ADDENDUM #2

NOTICE TO ALL BIDDERS FOR CITY OF WINCHESTER

ITB #201911 – Museum of Shenandoah Valley Trails

TITLE: MUSEUM OF THE SHENANDOAH VALLEY: PUBLIC TRAILS-SITE IMPROVEMENTS VDOT PROJECT: EN17-138-111; UPC 111418 PARTIAL GRADING PLAN (SECTION B)

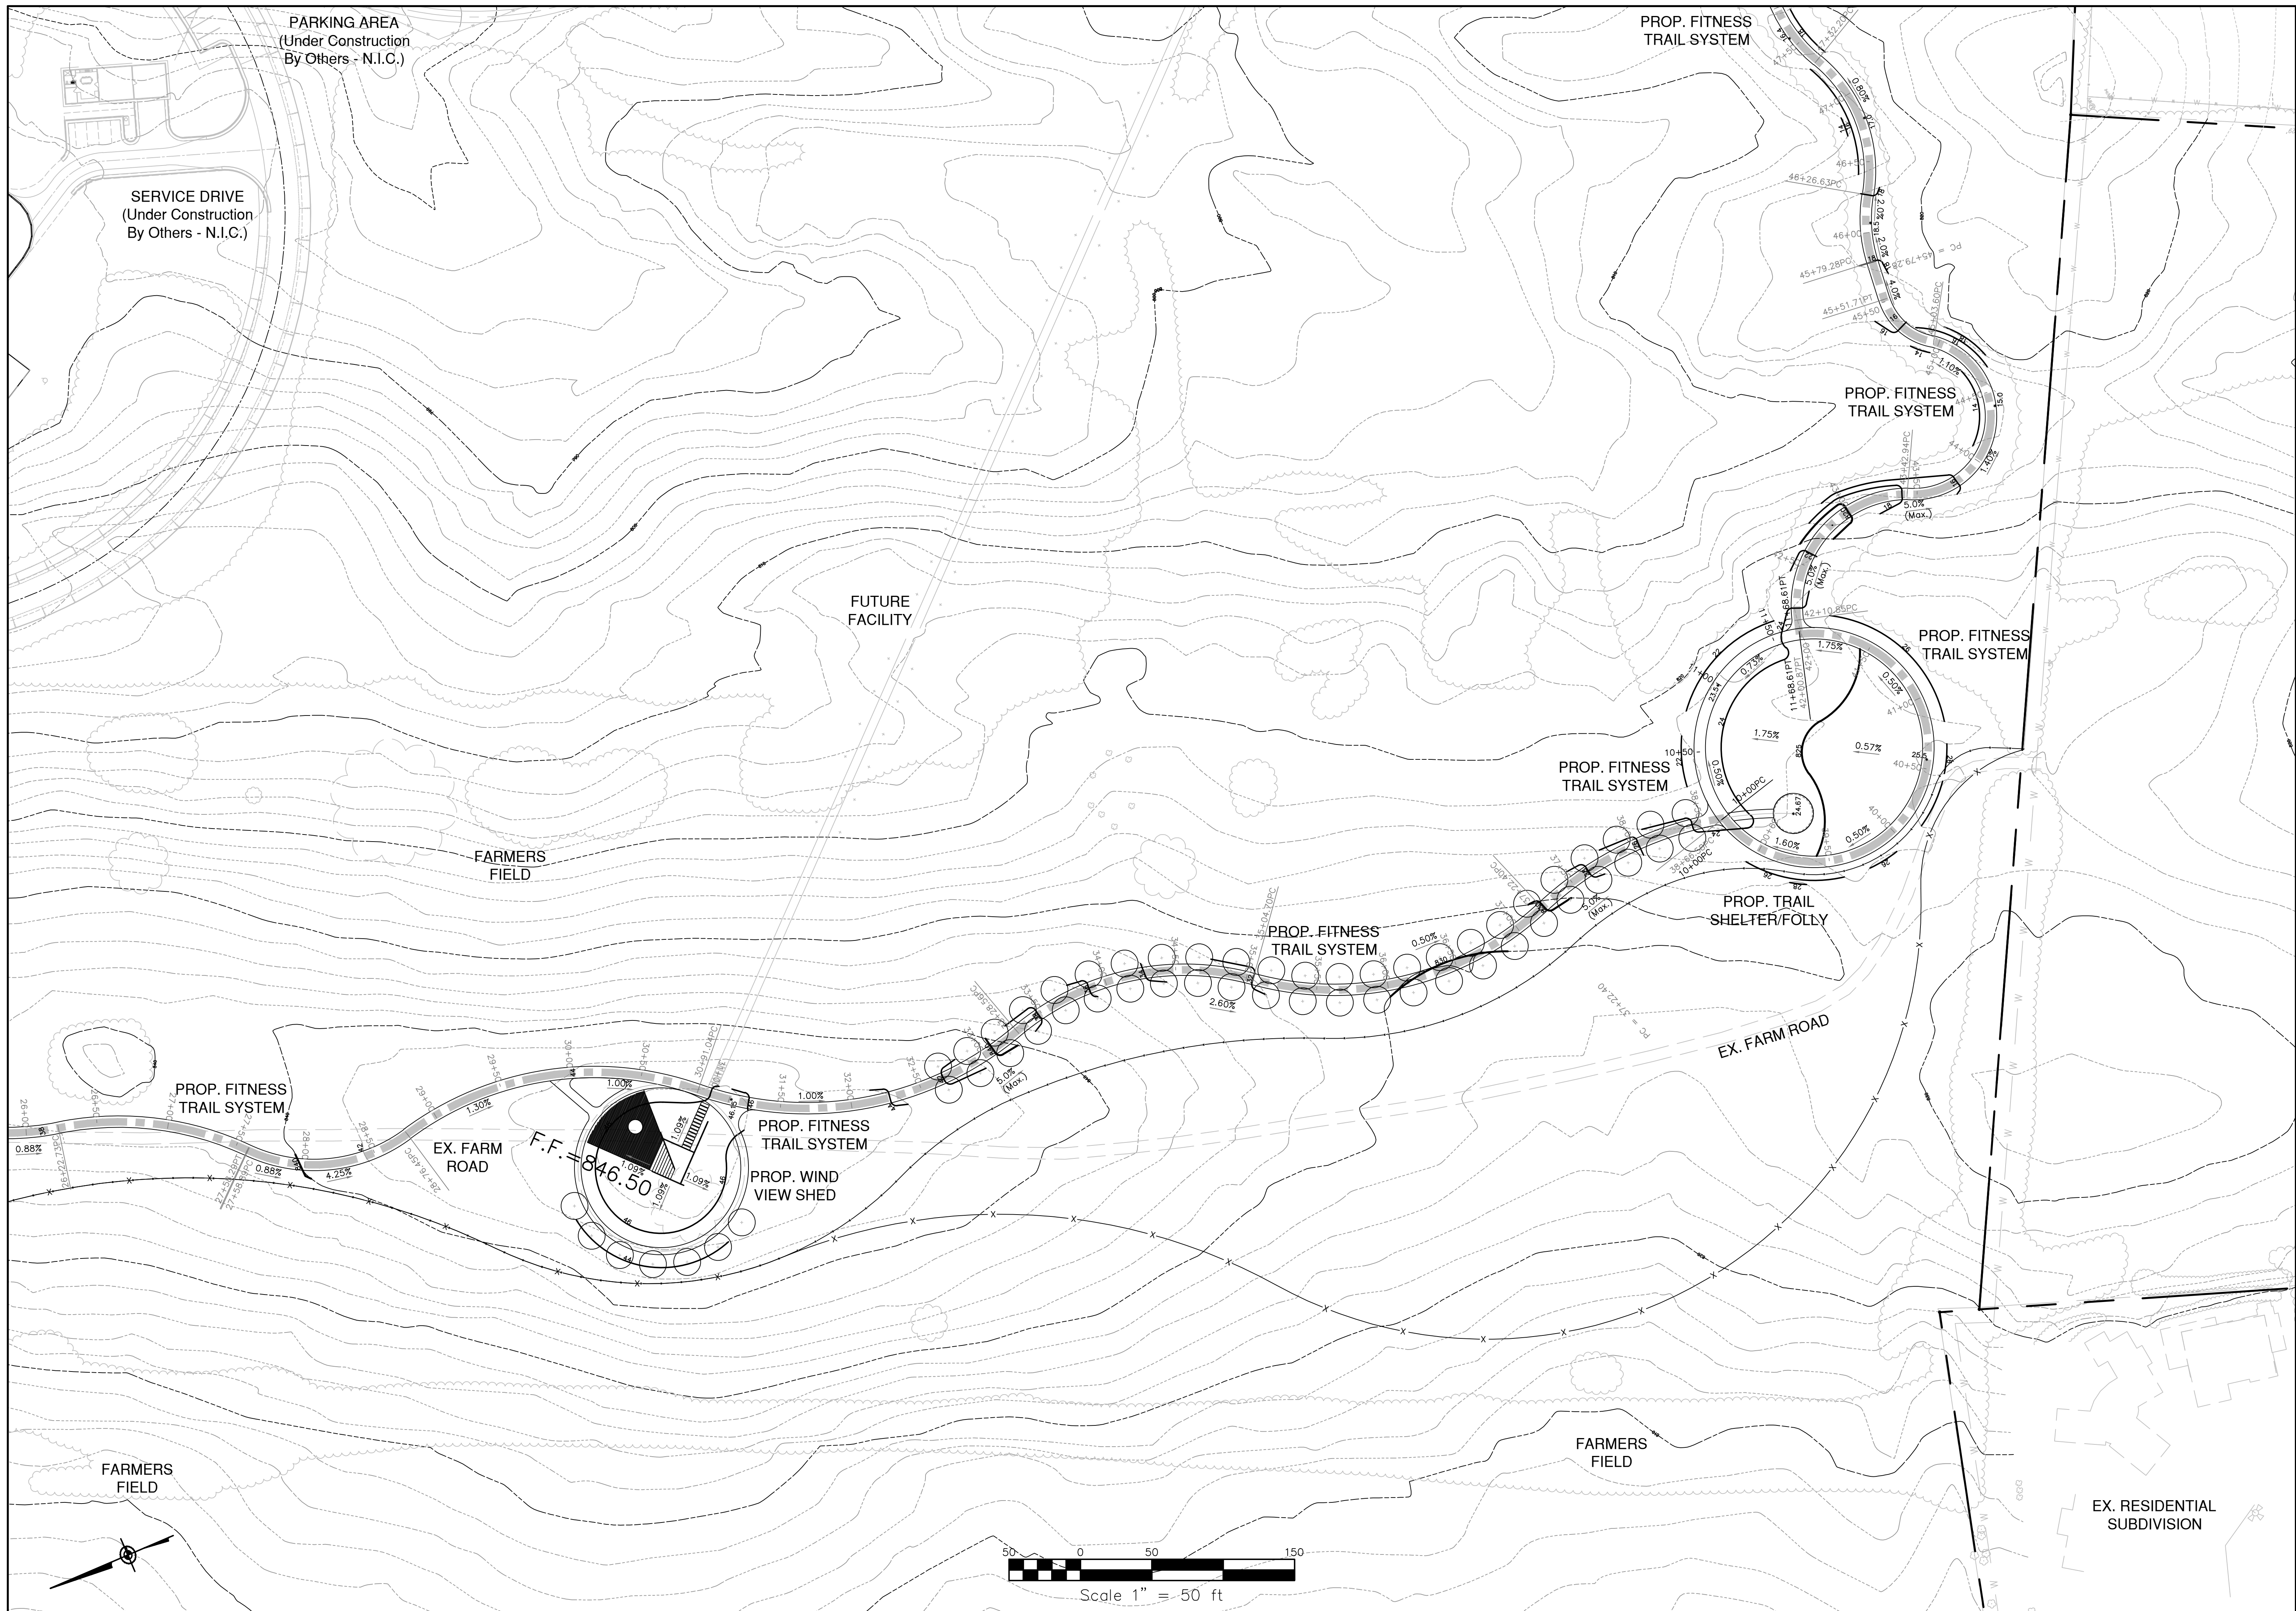
5. Sheet 8 of the contract drawings has been revised to include the grading of the wind view shed area. The additional grading shall be included in the Clearing & Grubbing and Earthwork bid items.
